INFORMATION NOTE

N° 023/20

Update of Information Note 023/20 dated 2020-03-09:

Introduction of new reel cover tape affecting SOT89, SOT223 and TSSOP10 package products packed at Infineon Technologies (Wuxi) Co. Ltd., Wuxi, China.

Description:
Reel cover tape

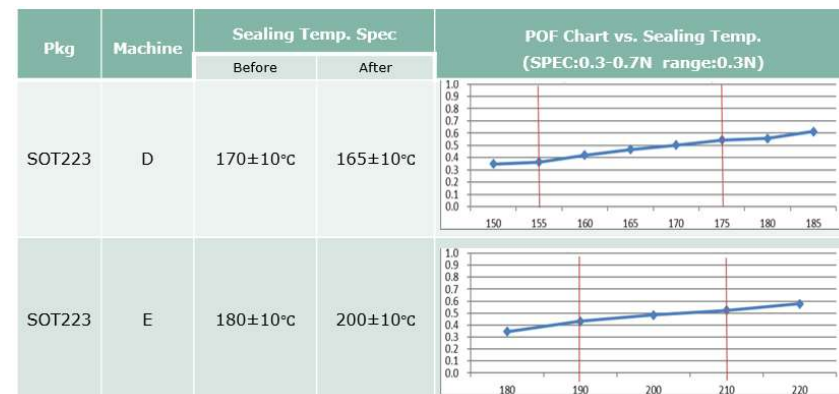
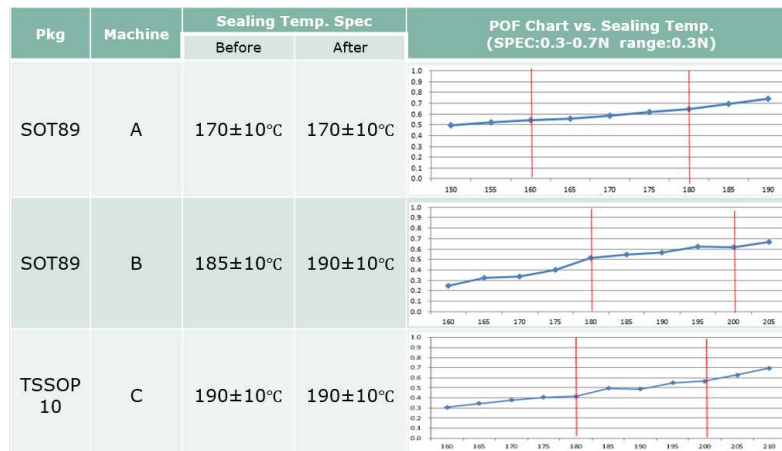
Old

(Picture taken from SOT89)

■ Milky white

New

(Picture taken from SOT89)

■ Transparent

► **Impact of Change:** No change of Form, Fit & Function of product. Cover tape change only.

- › Comparison of existing and new reel cover tape

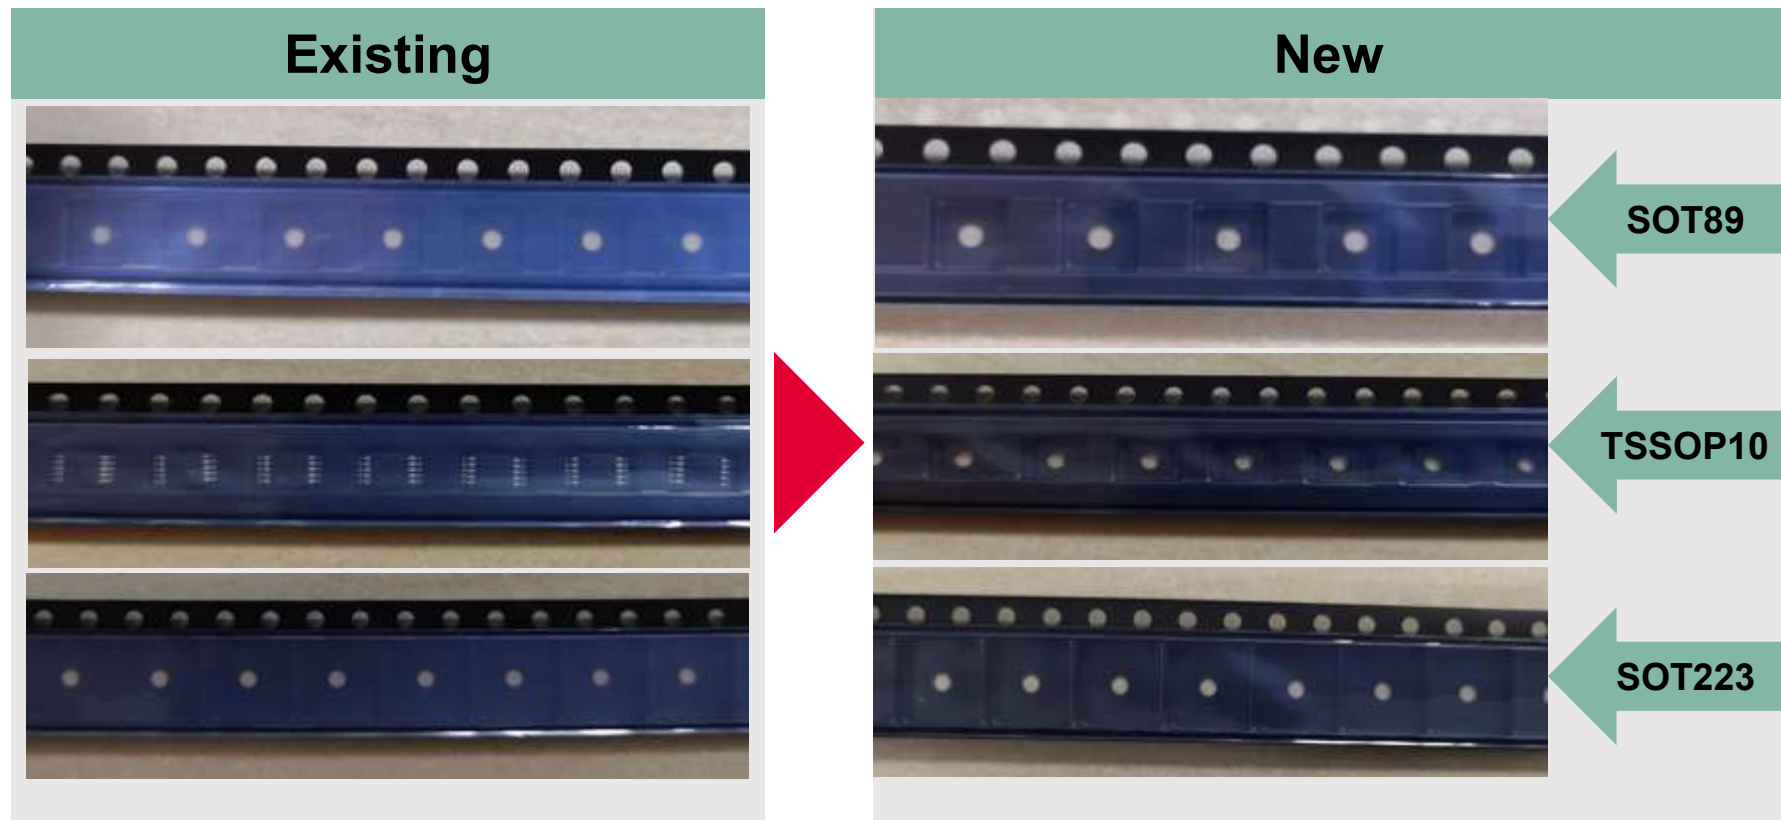
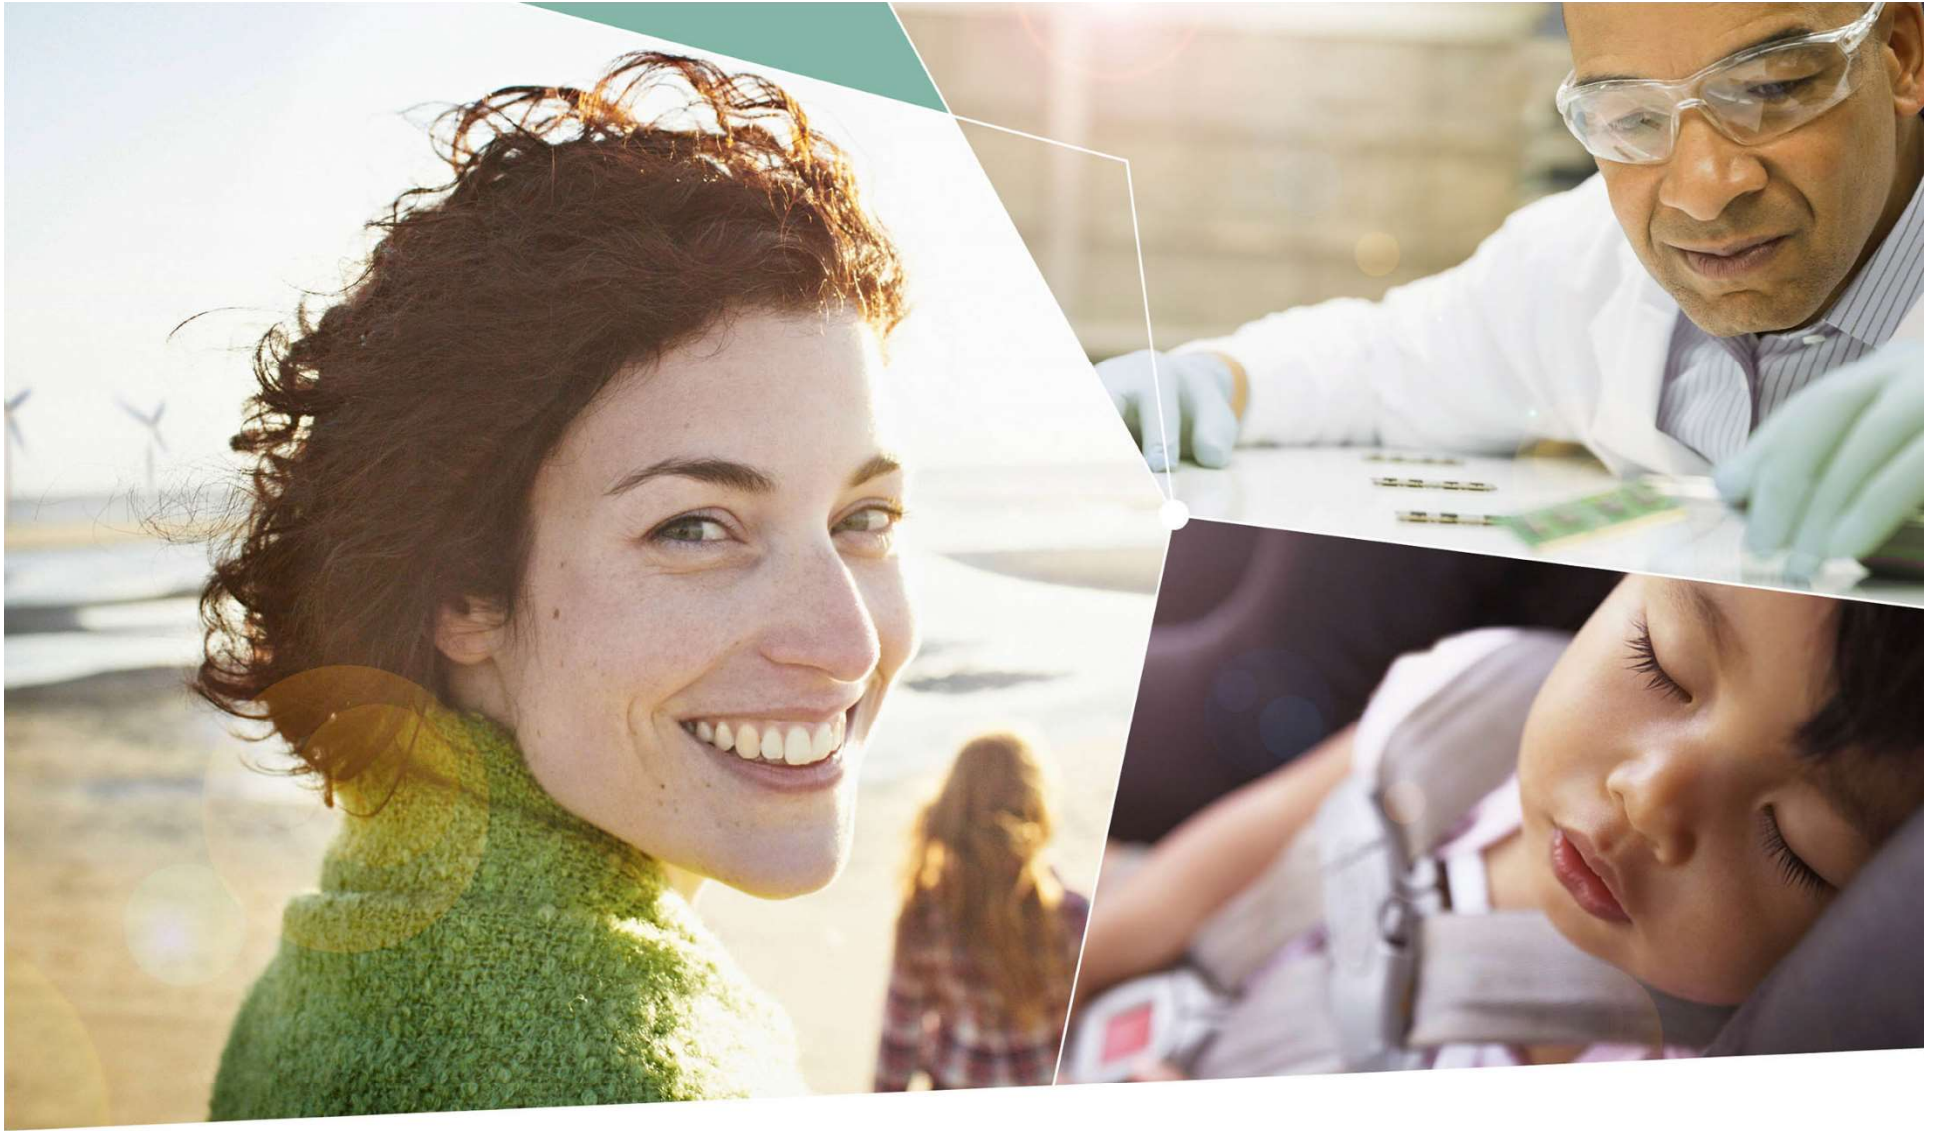
- › IQA checking all physical information in spec. [Verified according to spec]
 - Width, thickness, ESD, visual inspection, label.
- › Functional test on different machine. [Pass]
 - Seal temperature and peel-off force (POF) verification on different testing machine
 - Mechanical test and visual inspection

- › Conclusion.
 - No open tape, no sealing problem, no damage cover tape found.
 - New cover tape has better transparency and visibility.
 - New cover tape operate smoothly on machine, comparable with existing cover tape.
